Annex N

Buffer requirements for PFC

IEEE P802.1Q-Rev/D1.2

Draft Revision of IEEE Standard for Local and metropolitan area networks-Bridges and Bridged Networks

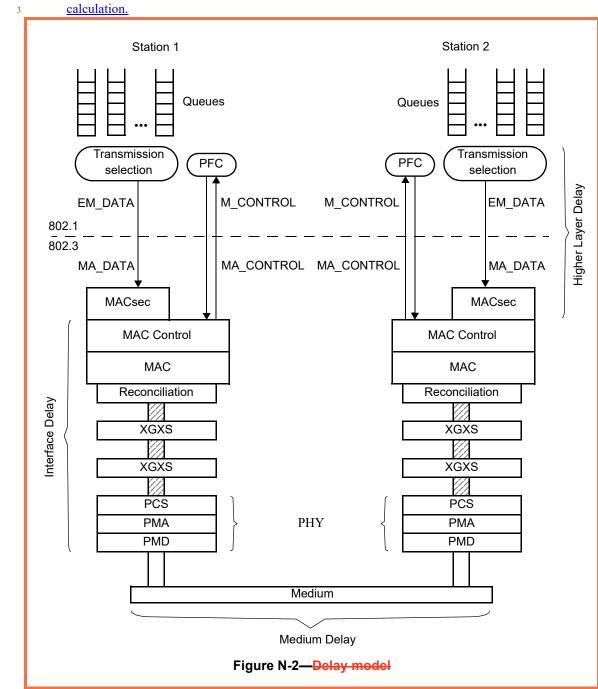
21 Figure N-2 shows how to model the various delays between two stations connected by a point-to-point full-22 duplex IEEE 802.3 link.

23 The main delay components shown in Figure N-2 are as follows:

24 When calculating PFC headroom, the delays are classified into 3 main components shown in Figure N-1, as 25 below:

26	a)	PFC transmission delay: the time needed by a station to request transmission of a PFC frame after			
27		a PFC M_CONTROL.request has been invoked (e.g., because a maximum length data frame can be			
28		t ransmitted).			
29	b)	Interface Delay (ID): the sum of MAC Control, MAC/RS, PCS, PMA, and PMD delays, including			
30		item e), g), k). Interface Delay is dependent on the MAC and physical layer in use.			
31	c)	Cable Delay: the number of bits in flight stored in the transmission medium. This delay value is			
32		dependent on the selected technology and on the medium length.			
33	d)	Higher Layer Delay (HD): the time needed for a queue to go into paused state after the reception of			
34		a PFC M CONTROL indication that paused its priority. A substantial portion of this delay			
35		component is implementation specific.			
36	a)	Internal processing delay (ID): the time spent on frame processing within PFC initiator station and

37	,	PFC receiver station, such as interface stack delay, and buffering delay etc, queue status change			
38		delay, assuming no prior in-progress frame transmission. ID includes item a) b) d) e) g) h) j) l).			
39	b)	Link delay (LD): the time spent on physical link between PFC initiator station and PFC receiver			
40		station. LD includes item f) and item k).			
41	c)	Worst-case delay (WD): the additional time needed for a maximum sized frame transmission			
42	,	before the PFC frame transmission at PFC initiator station, and the additional time needed for a

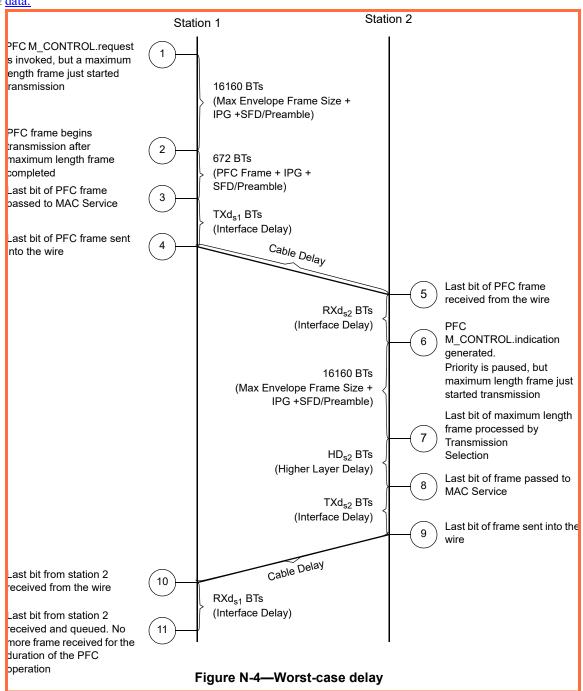
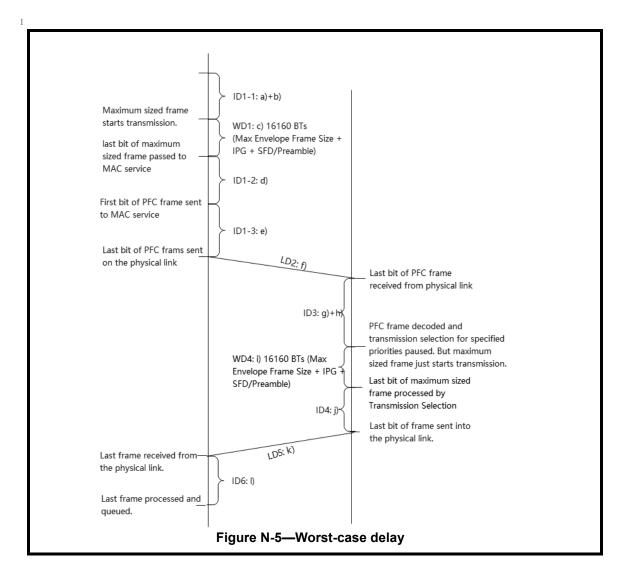
Figure N-4 shows a possible worst-case delay example where MACsec is disabled for PFC frame and user

3 The total Delay Value (DV) is the sum of all delays shown in Figure N-4:

4 $DV = 2 \times (Max Frame) + (PFC Frame) + 2 \times (Cable Delay) + TXd_{s1} + RXd_{s2} + HD_{s2} + TXd_{s2} + S$ 5 RXd_{s1}

$6 \qquad \underline{DV = ID_1 + WD_1 + LD_2 + ID_3 + WD_4 + ID_4 + LD_5 + ID_6}$
